Access Compliance Report

Public Rights-of-Way

(Curb Ramps)

Intersection ID: 9651	Main Street: CRESTVIEW_DR	Cross Street: FRENCH_ST	Location: W
ADA ID: FF3759227AD8	Ramp Type: BlendTrans1	Initial Pass/Fail: Pass	Overall Compliance: No
			Severity Score: 10

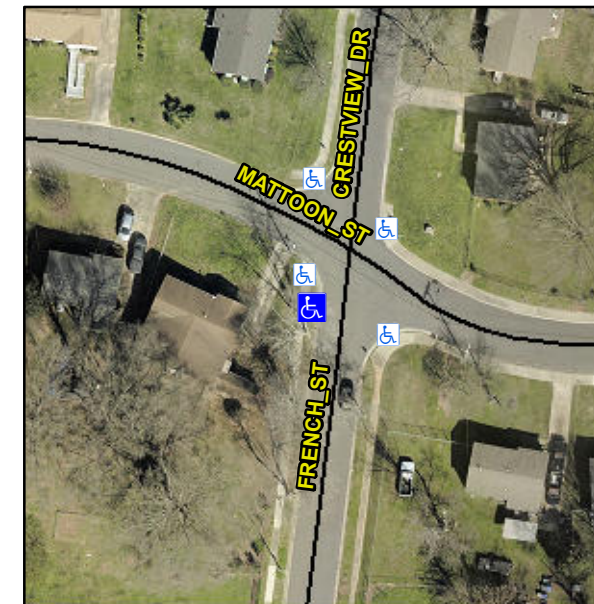
Not Found, R304.2.2-Perp, R304.3.2-Para, R304.5.3, R305.1.4, R305.2, R302.7.2

Compliance	Description	Data	Compliance	Description	Data
N/A	Ramp Length (in)	53.0	Yes	BlendTrans Slope (%)	5.0
Yes	Ramp Width (in)	58.0	Yes	BlendTrans XSlope (%)	1.3
Yes	Flare Type L	Curbed_NoWalkSurface	Yes	Flare Type R	Curbed_NoWalkSurface
N/A	Flare Slope LT (%)	N/A	N/A	Flare Slope RT (%)	N/A
N/A	Flare Traversable LT?	No	N/A	Flare Traversable RT?	No
Yes	Landing Length (in)	59.0	Yes	DWS Provided?	Yes
Yes	Landing Width (in)	55.5	Yes	DWS Contrast?	Yes
No	Landing Slope (%)	2.5	Yes	DWS Length (in)	25.0
No	Landing X Slope (%)	5.2	No	DWS Full Width?	No
N/A	Landing Curb? (Y/N)	No	No	DWS Offset (in)	4.0
N/A	Shared Landing?	Yes			
Yes	Gutter Ponding?	No	Yes	Gutter Slope (%)	3.5
No	Gutter Lip Ht (in)	0.5	Yes	Gutter X Slope (%)	1.6
N/A	Painted X Walk1?	No	N/A	Painted X Walk2?	N/A
	X Walk 1 Direction	To E		X Walk 2 Direction	N/A
	X Walk 1 Width (in)	N/A		X Walk 2 Width (in)	N/A
	X Walk 1 Slope (%)	6.7		X Walk 2 Slope (%)	N/A

X Walk 1 X Slope (%)	1.4		X Walk 2 X Slope (%)	N/A
N/A	Ramp inside XWalk1?	N/A	N/A	Ramp inside XWalk2?	N/A
	Road Slope (%)	1.4		Clear Space?	Yes
	Road X Slope (%)	6.7	N/A	Clear Space to XWalk (in)	N/A
Yes	Any Obstructions?	No	Yes	Storm Grate/Utility Hazard?	No
	Obstruction Type			Storm Grate/Utility Type	
		N/A			N/A
			Yes	Surface Condition? (G/P)	Good
			No	Curb Slope (%)	18.1

Remove & Replace Curb Ramp With Two New Directional Ramps or Equivalent.
